Meeting Agenda

Historic Zoning Commission

Monday, March 10, 2025

ELEVATION // RIGHT SIDE

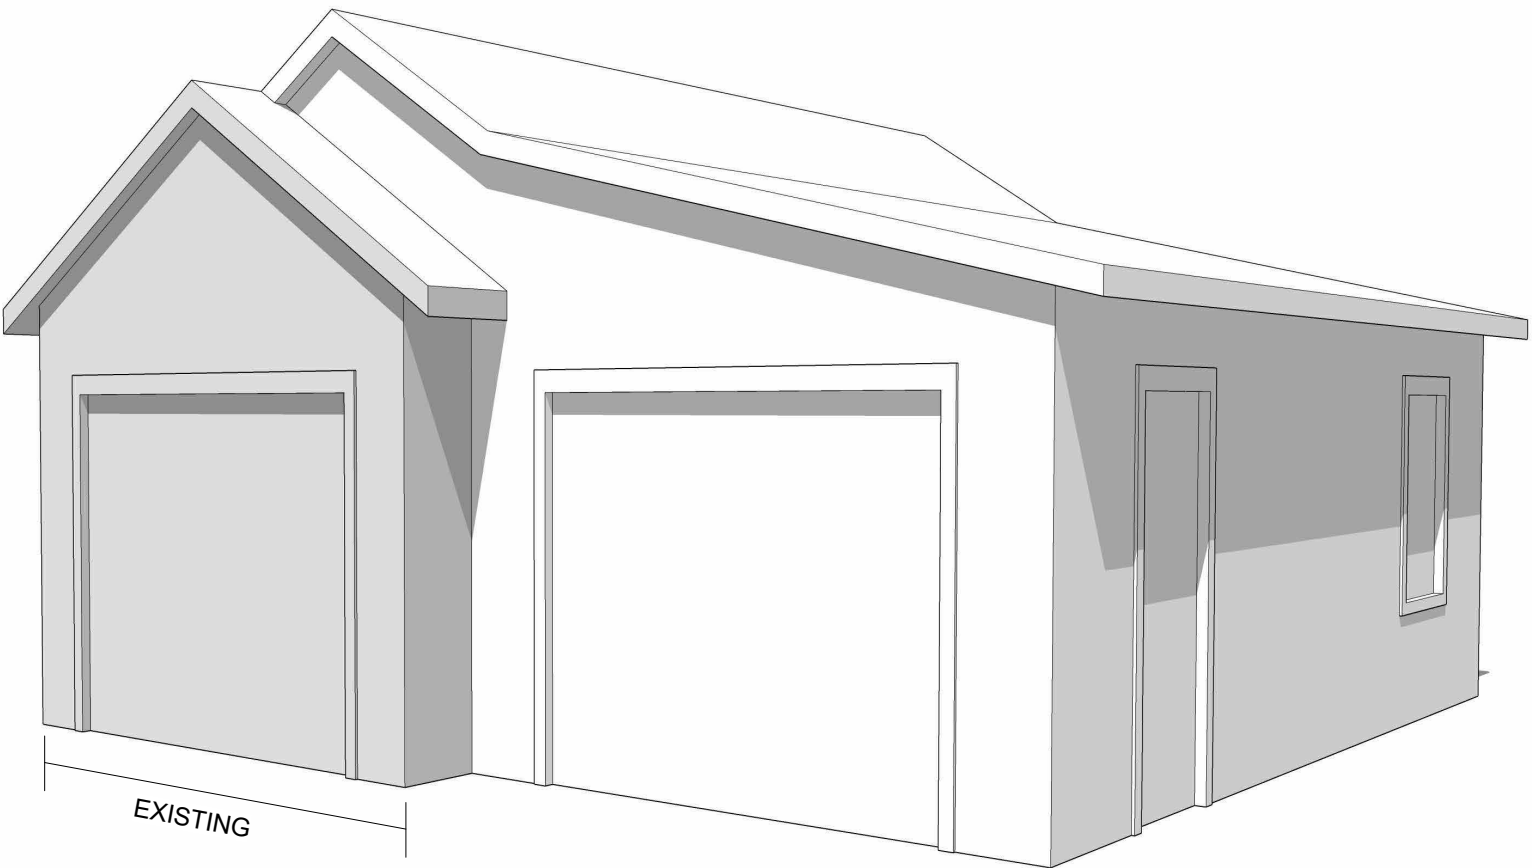
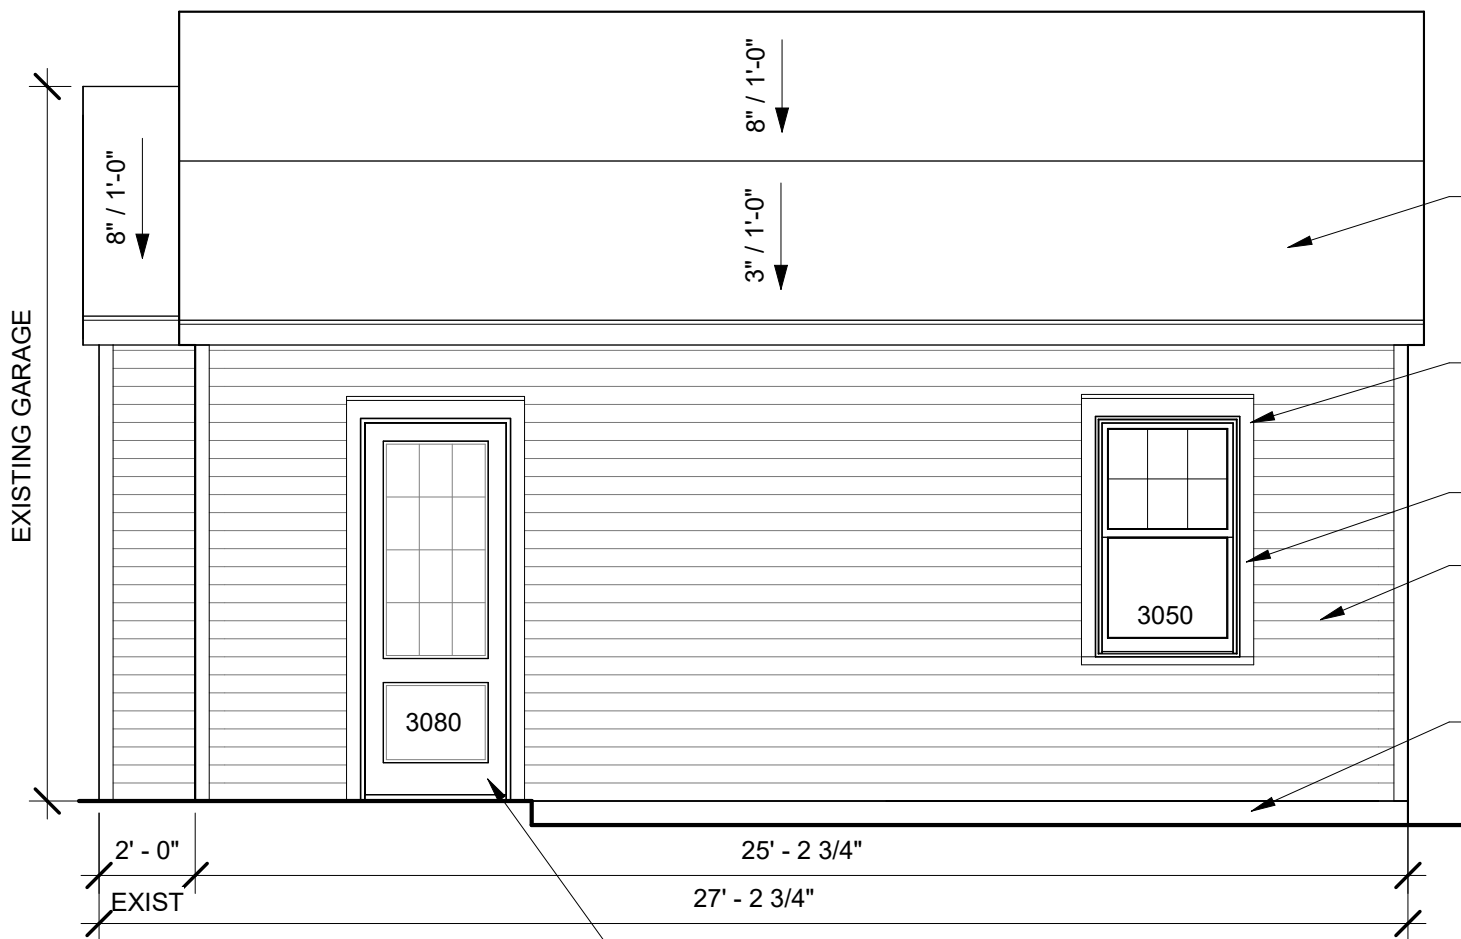
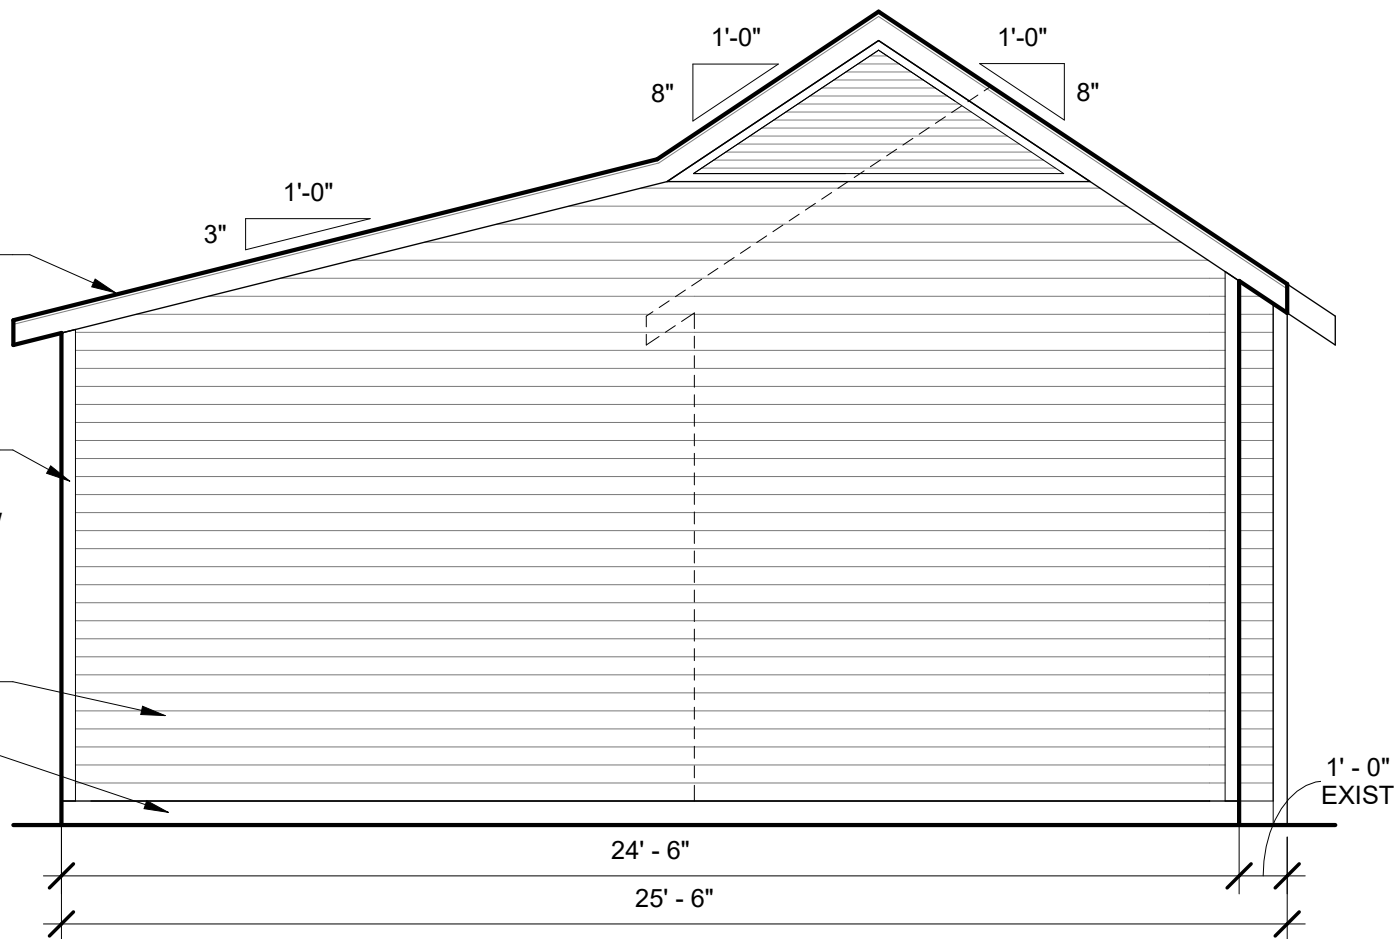
The existing wood frame accessory structure is 201.44 sq. ft. It is proposed to add a 456 sq. ft. addition to the structure to equate to a structure that will measure 657.77 sq. ft. The addition will wrap behind the existing structure and to the right of the structure. The addition will utilize a wood or composite lap siding that will match the reveal of the existing accessory structure and the asphalt roofing material to match the existing roofing material. The addition will utilize insets/offsets and a change in roof pitch to define the addition from the existing structure. The unique roof form that is

While the addition does utilize insets, offsets, and roof breaks, and similar roof form elements as the principal building, the height of the addition is not subordinate to the historic accessory building according to the Guidelines. When the application came before the DRC, the DRC members supported the relocation and addition to the accessory structure. Window specifications have not been provided as a part of this application, this will need to be sent to Preservation Planning staff prior to permitting.

1. Window specifications must be provided to the Preservation Planner before the issuance of a building permit.
